Access Compliance Report Public Rights-of-Way (Curb Ramps)

Main Street: DEAN_ST Cross Street: IRVINE_BLV Location: W

ADA ID: RPRK211014144957 Ramp Type: Type 4 - Parallel Initial Pass/Fail: Fail Overall Compliance: No Severity Score: 2

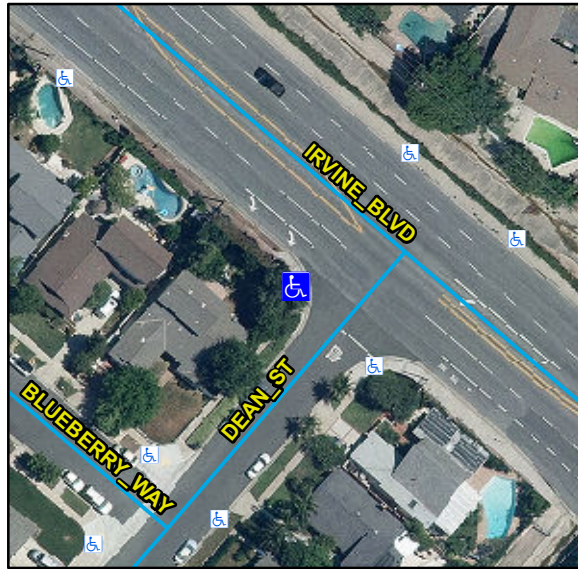
Compliance	Description	Data	Compliance	Description	Data
N/A	Ramp Length LT (in)	68	N/A	Ramp Length RT (in)	154
Yes	Ramp Width LT (in)	102	Yes	Ramp Width RT (in)	100
Yes	Ramp Run Slope LT (%)	5.4	Yes	Ramp Run Slope RT (%)	6.6
No	Ramp Cross Slope LT (%)	2.2	Yes	Ramp Cross Slope RT (%)	1.3
N/A	Landing Present	N/A	N/A	DWS Provided	N/A
N/A	Landing Length (in)	N/A	N/A	DWS Contrast	N/A
N/A	Landing Width (in)	N/A	N/A	DWS Length (in)	N/A
N/A	Landing Run Slope (%)	N/A	N/A	DWS Full Width	N/A
N/A	Landing Cross Slope (%)	N/A		DWS Offset Type	N/A
N/A	Landing Movement Obstructed?	N/A	N/A	DWS Offset Left (in)	N/A
	Landing Movement Type	N/A	N/A	DWS Offset Right (in)	N/A
N/A	Landing Shared	N/A			
N/A	Clear Space	Yes			
N/A	Clear Space To Crosswalk (in)	N/A			
N/A	Marked Crosswalk 1	No	N/A	Marked Crosswalk 2	No
	Crossing 1 Direction	SE		Crossing 2 Direction	NE
	Marked Crosswalk 1 Width (in)	N/A		Marked Crosswalk 2 Width (in)	N/A

N/A	Ramp Inside Crosswalk 1	N/A	N/A	Ramp Inside Crosswalk 2	N/A
	Crossing 1 Slope (%)	5.2		Crossing 2 Slope (%)	7.5
	Crossing 1 Cross Slope (%)	2.8		Crossing 2 Cross Slope (%)	0.4
N/A	Gutter Ponding	N/A	N/A	Curb Slope	4
Yes	Gutter Lip Height (in)	0		Road Run Slope (%)	0.8
N/A	Gutter Run Slope (%)	N/A		Road Cross Slope (%)	4.5
N/A	Gutter Cross Slope (%)	N/A	Yes	Perpendicular Joint Present	Yes
Yes	Overall Surface Condition	Acceptable			
	Cross Gutter Present?	No		Spandrel Present?	No
	Replace Cross Gutter?	N/A		Replace Spandrel?	N/A

Remove & Replace Curb Ramp With Two New Directional Ramps or Equivalent.

R304.5.3, STD 1115
